STANDARD DEPARTURE CHART
INSTRUMENT(SID) - ICAO

JEJU/Jeju Intl(RKPC)

RWY 07

JEJU/Jeju Intl(RKPC)
RWY 07
IPDAS 4K, MAKET 4K
TAMNA 2K, CJU 4K

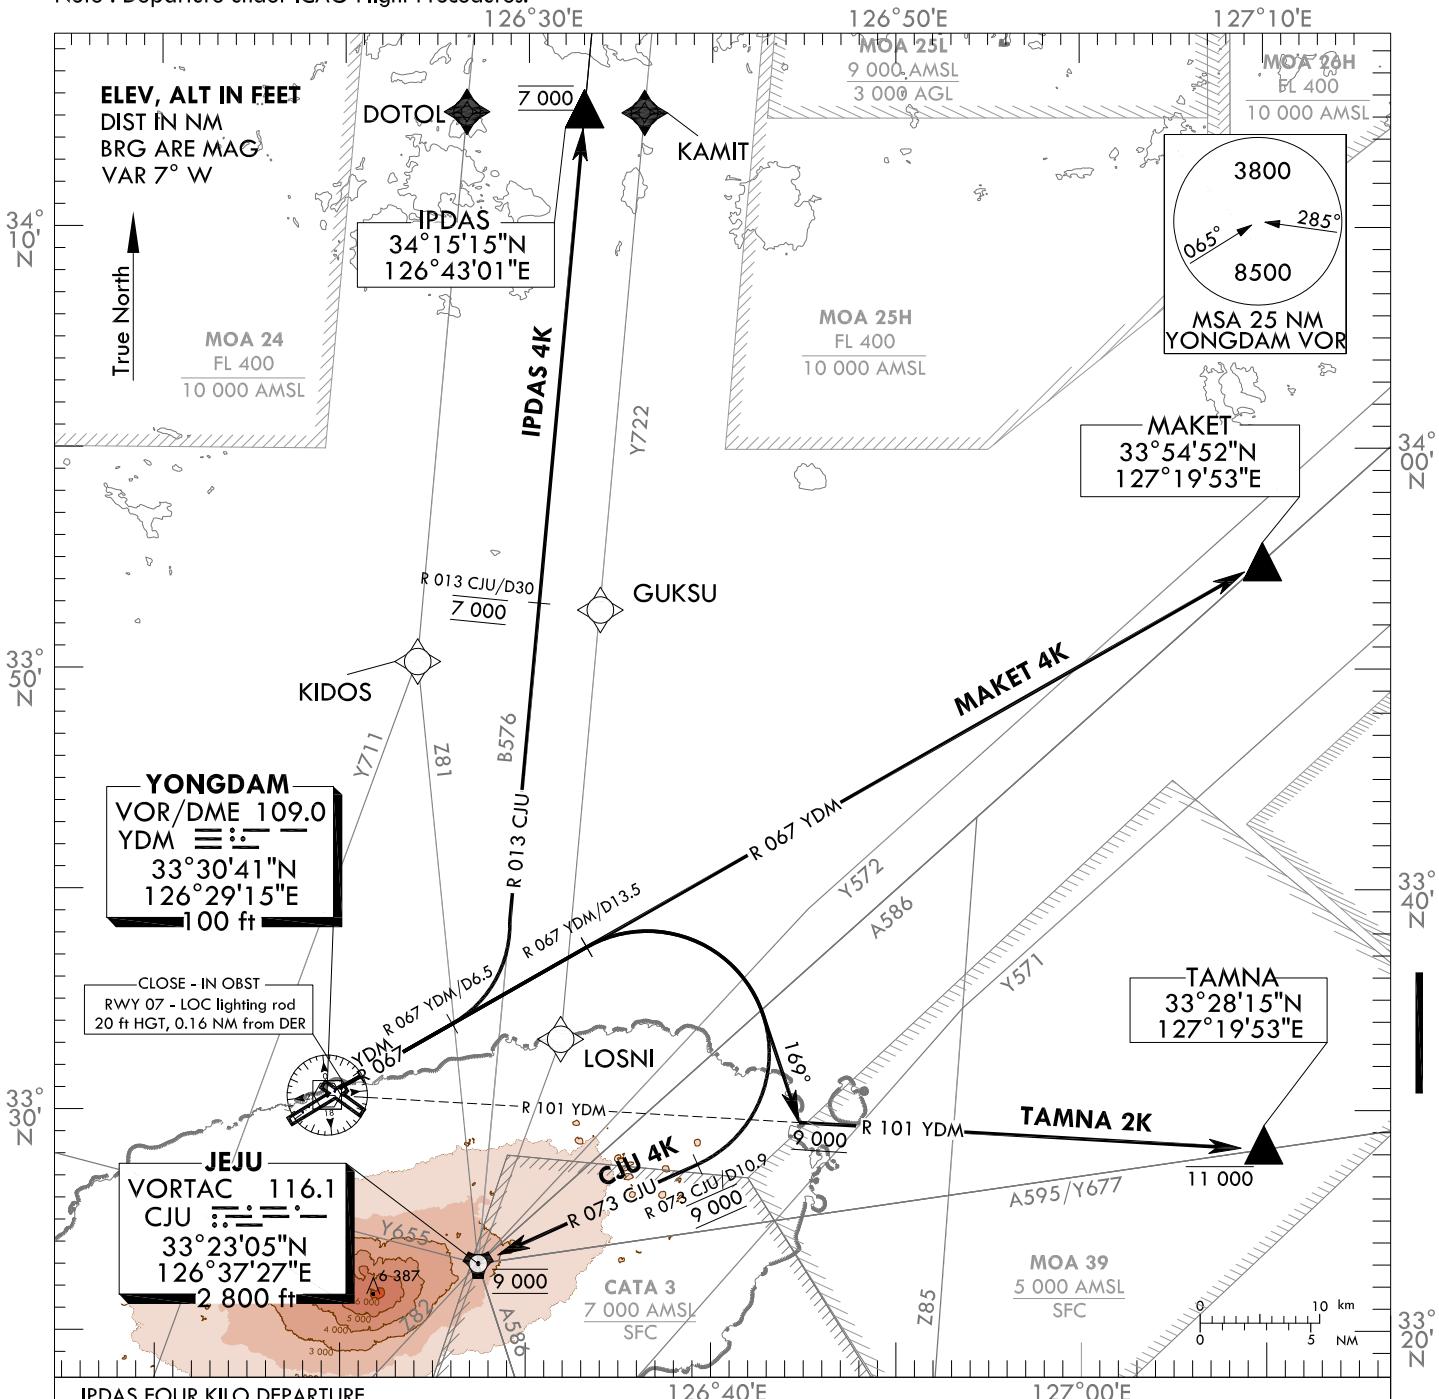
Change : Establishment of close-in OBST.

RWY 25
RNAV KAMIT 1W, RNAV IPDAS 1W
RNAV AKPON 1W, RNAV TAMNA 3W
RNAV PANSI 2W, RNAV LIMDI 1W

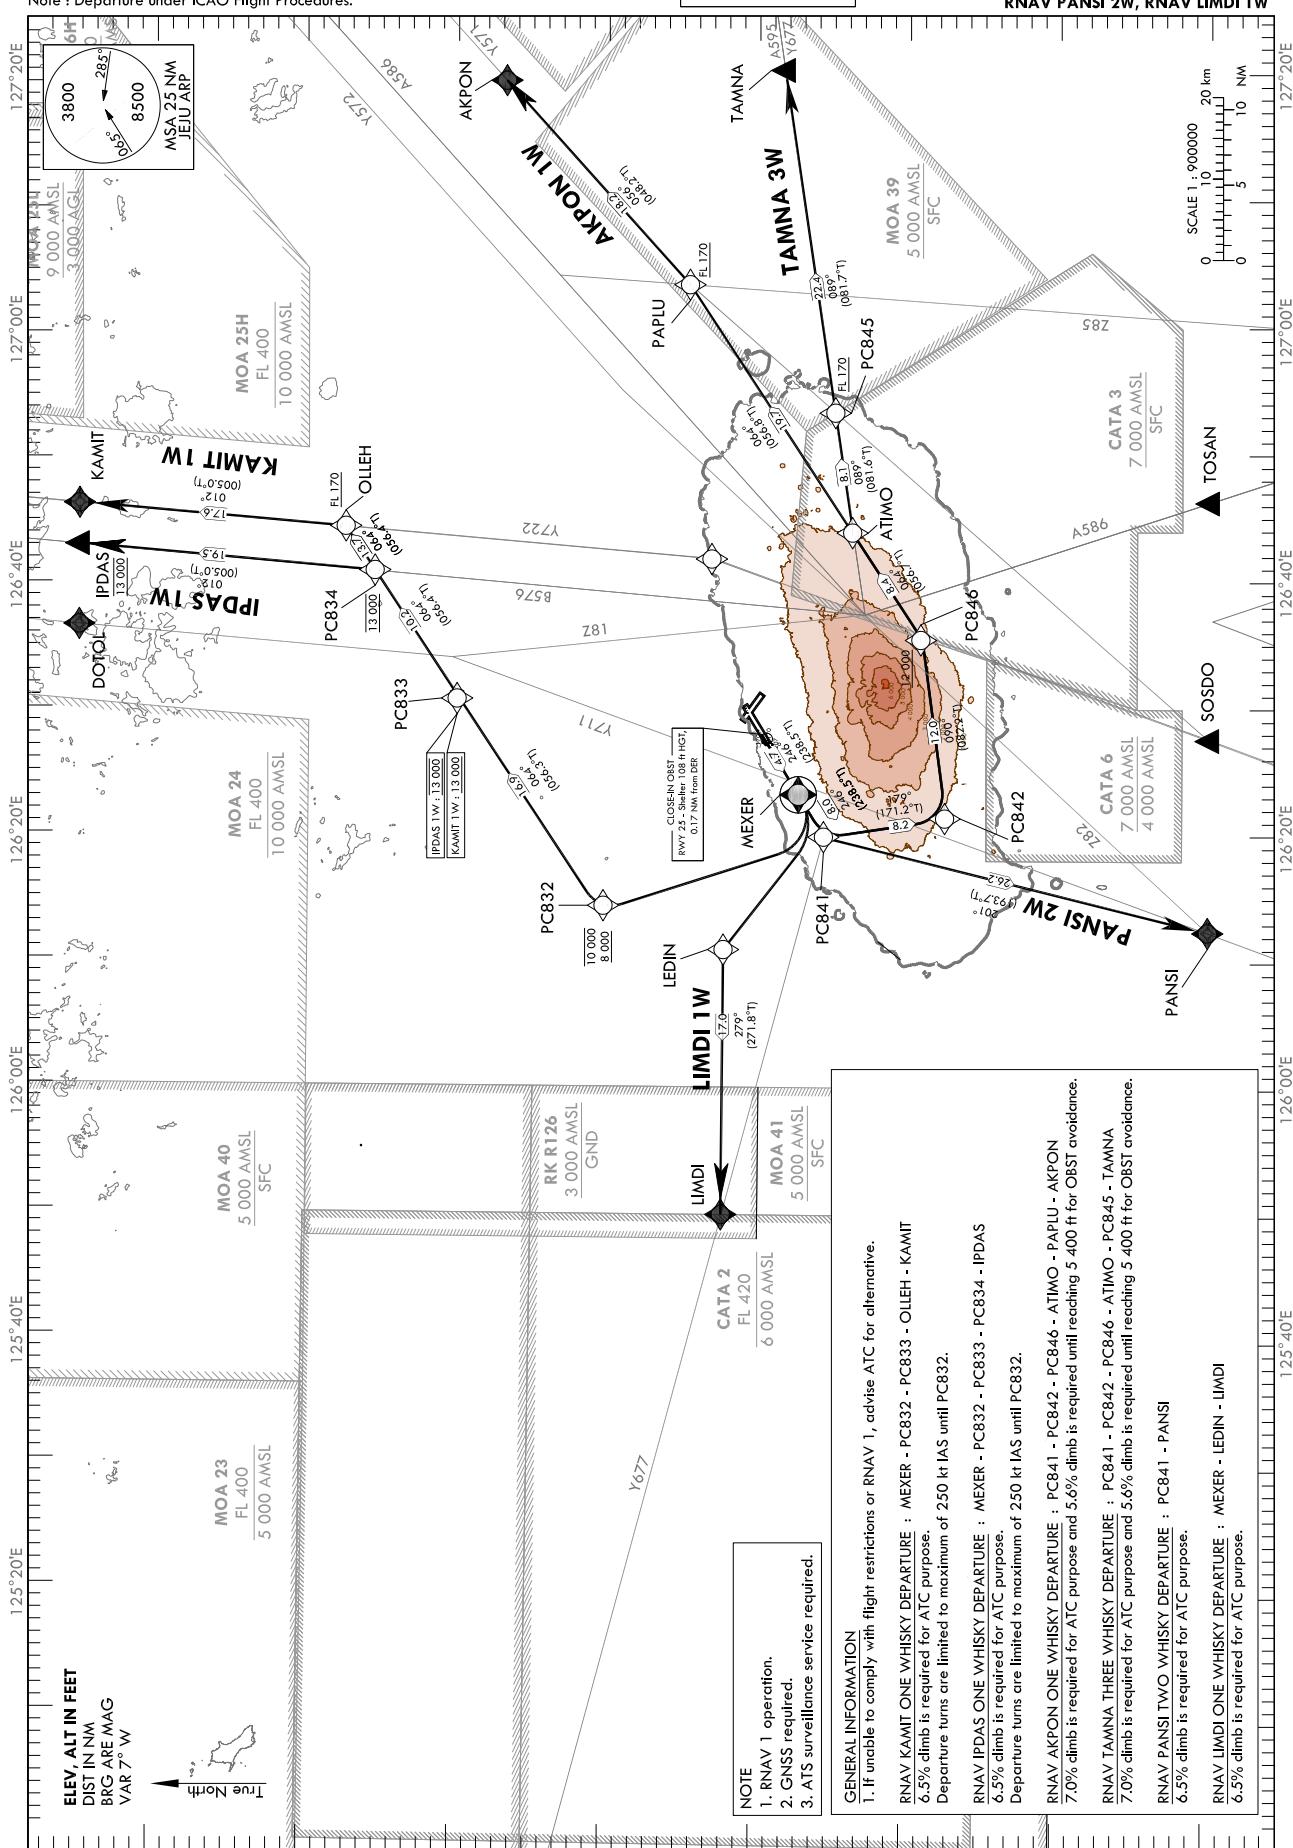
Change : Amended phrase(VPA/TCH → VPA/RDH).

**JEJU/Jeju Int'l(RKPC)
RWY 25
CJU 3L, IPDAS 1L**

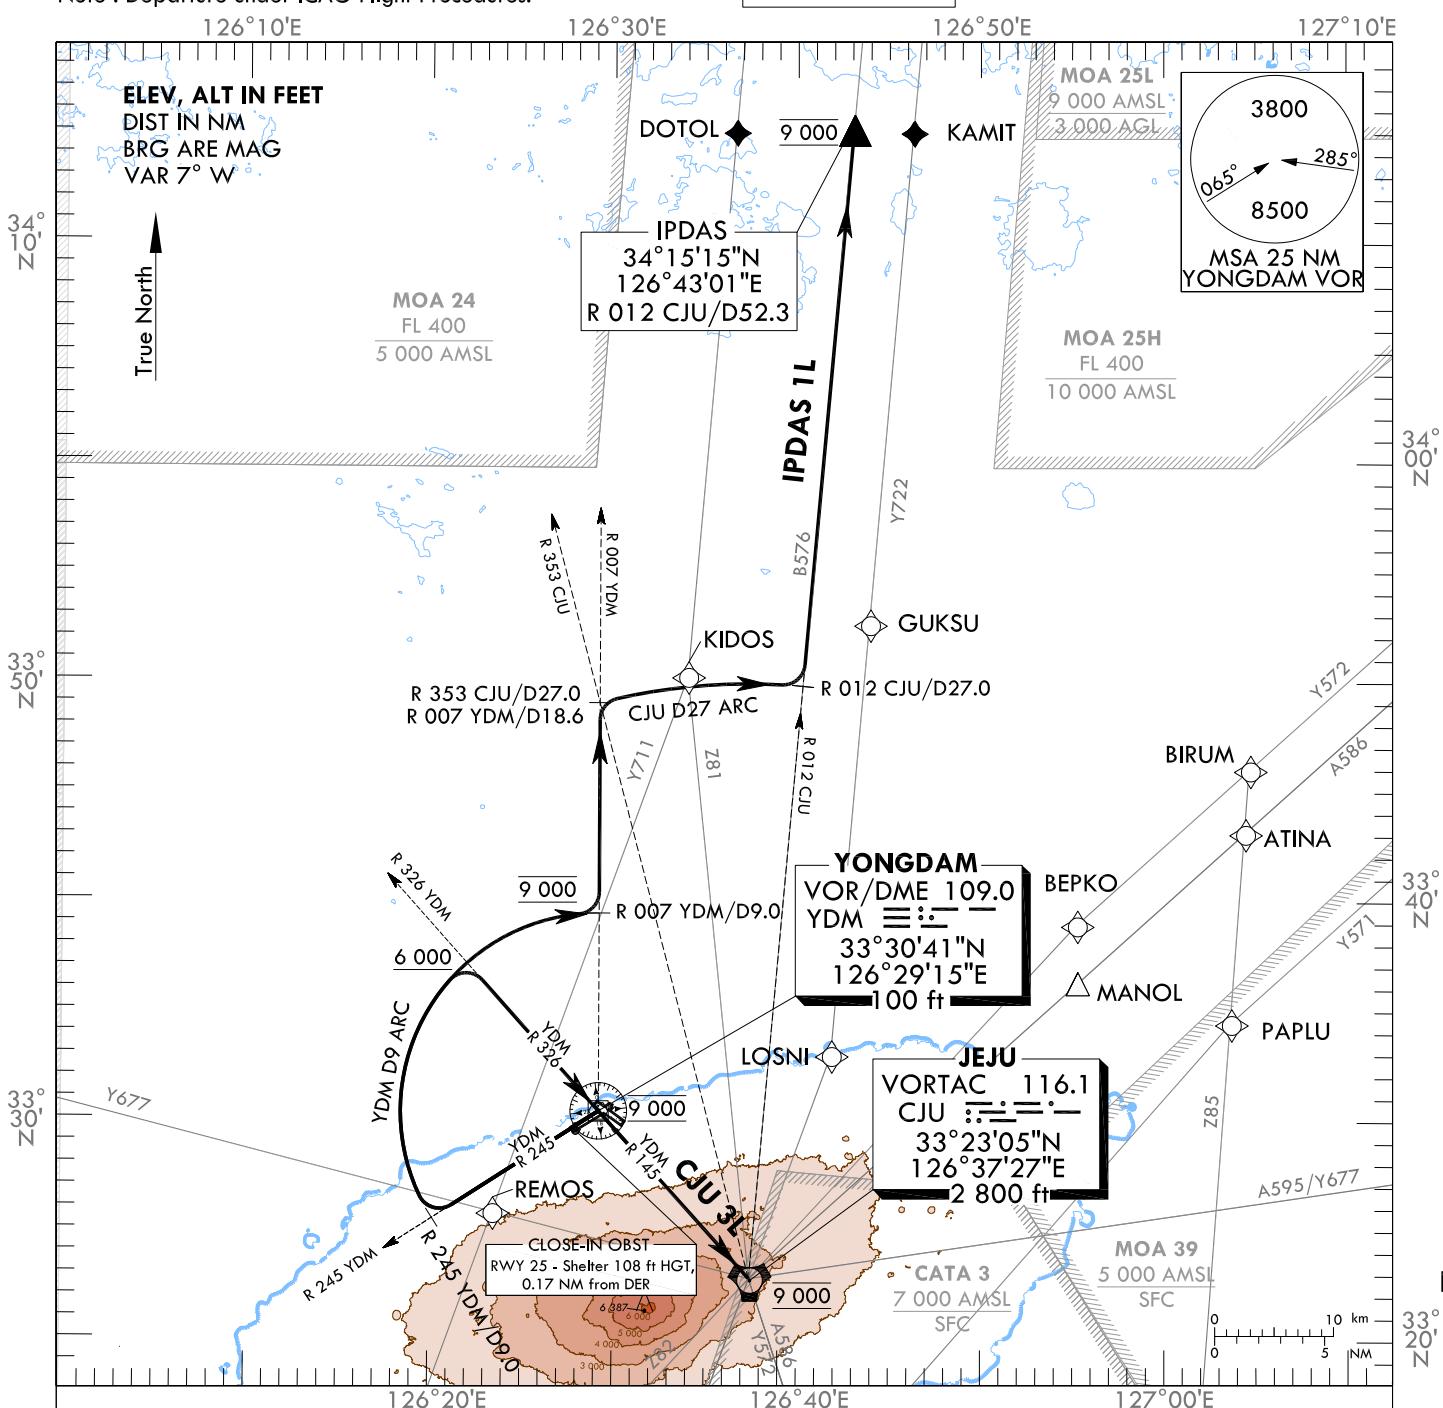
Change : Amended phrase(0.003 NM → 0.17 NM).

RWY 31

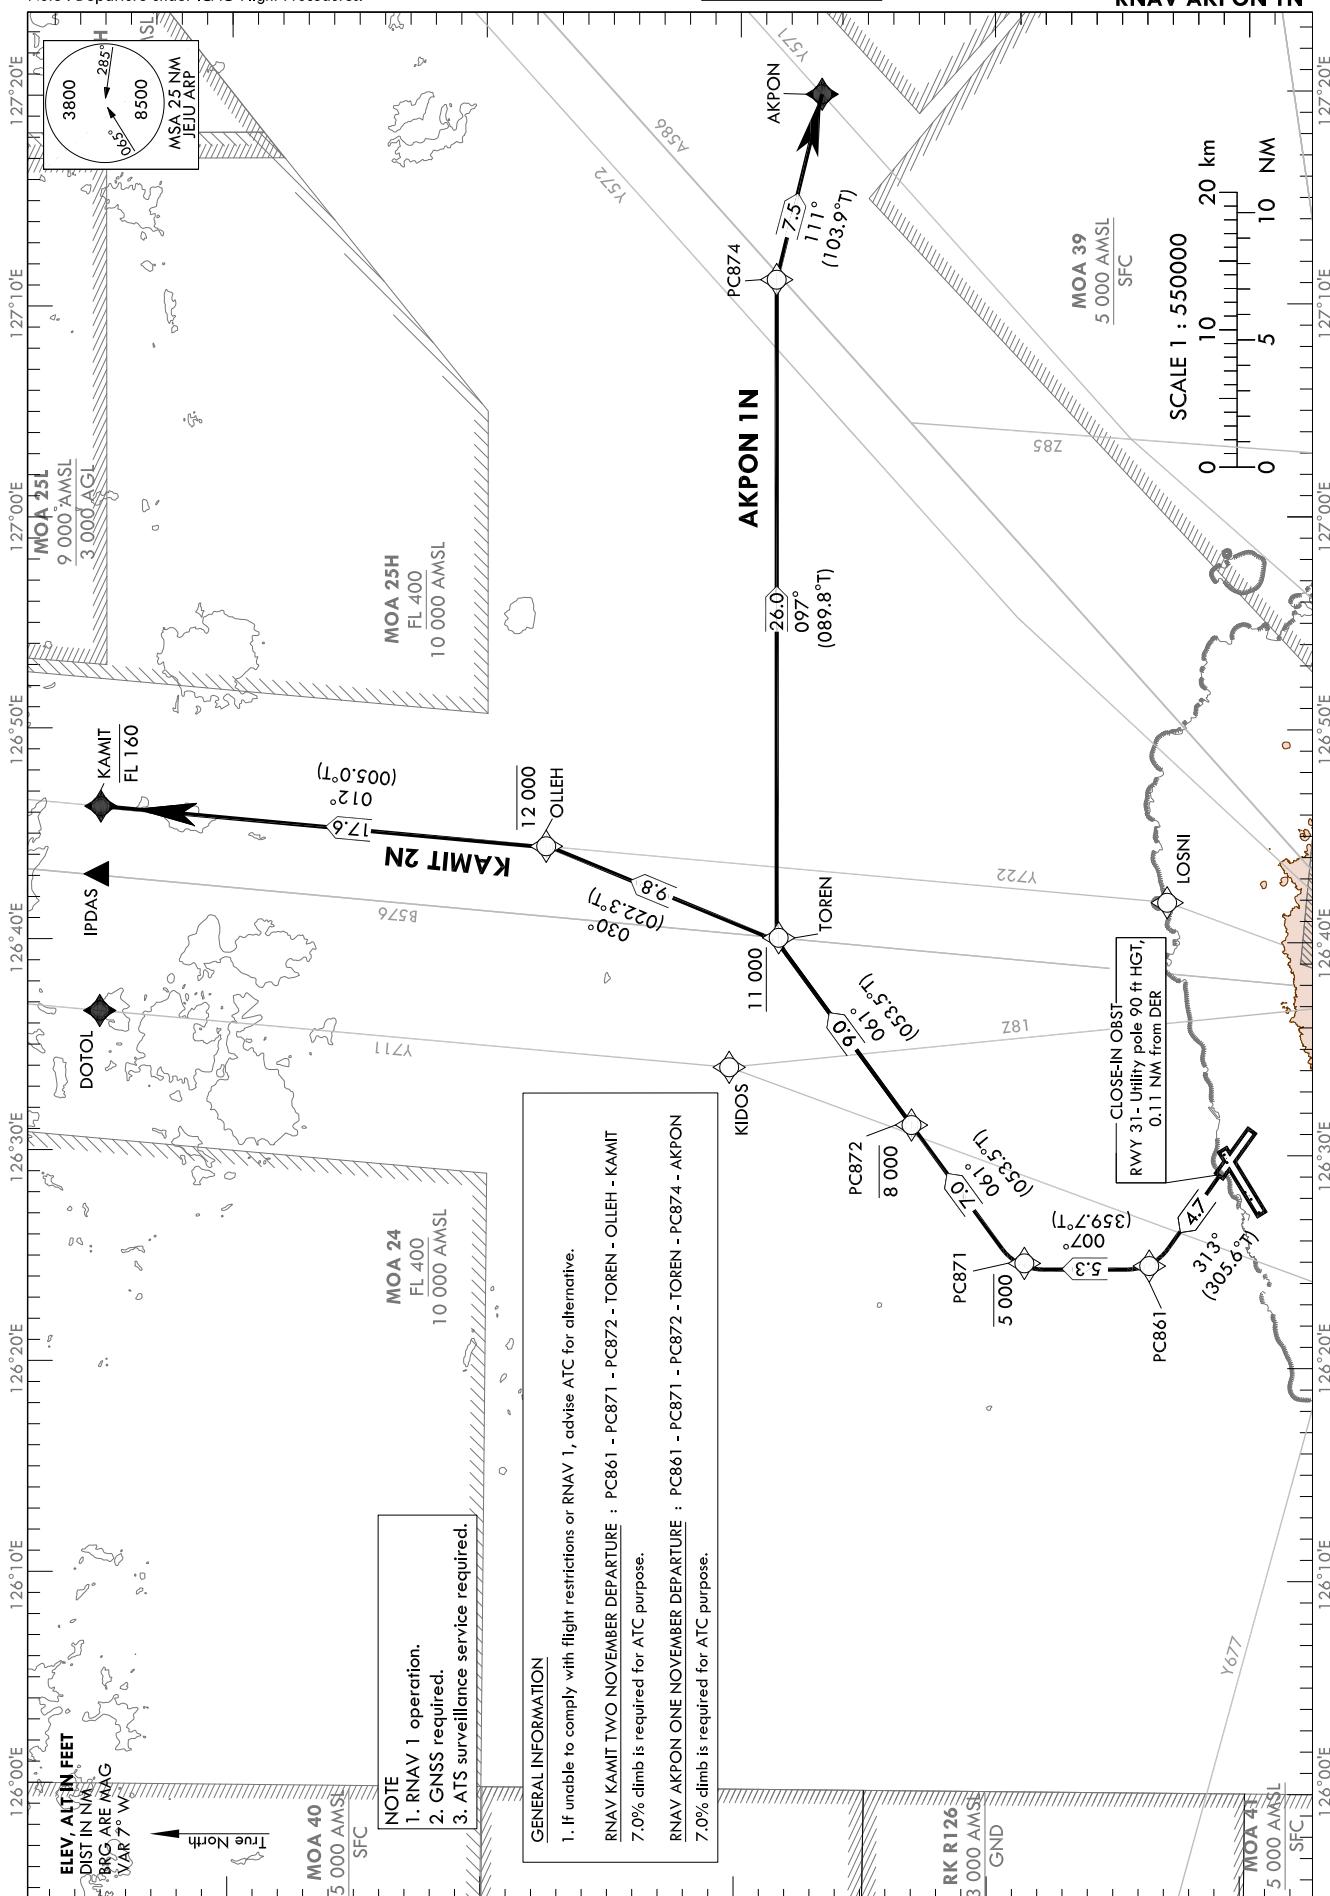
Change : Establishment of close-in OBST.

JEJU/Jeju Intl(RKPC)
RWY 07 RADAR 2E
RWY 25 RADAR 3W
RWY 31 RADAR 1N

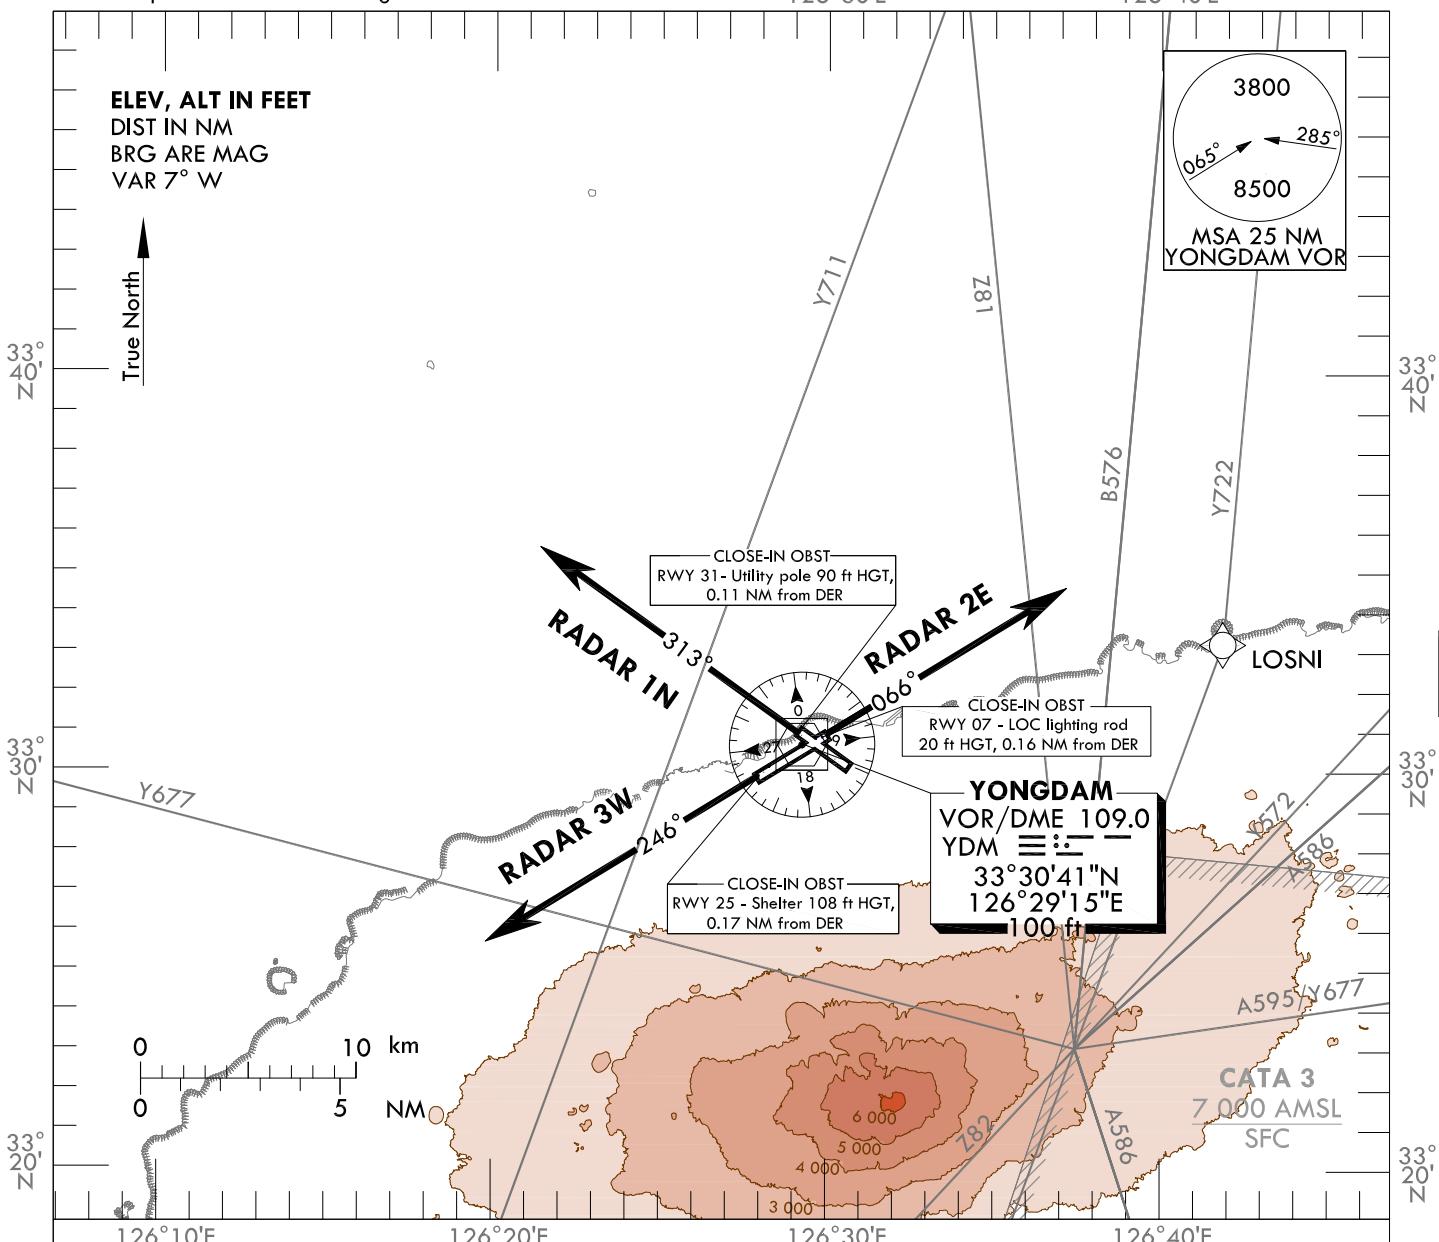
Change : Amended radial(312° → 313°, 065° → 066°).
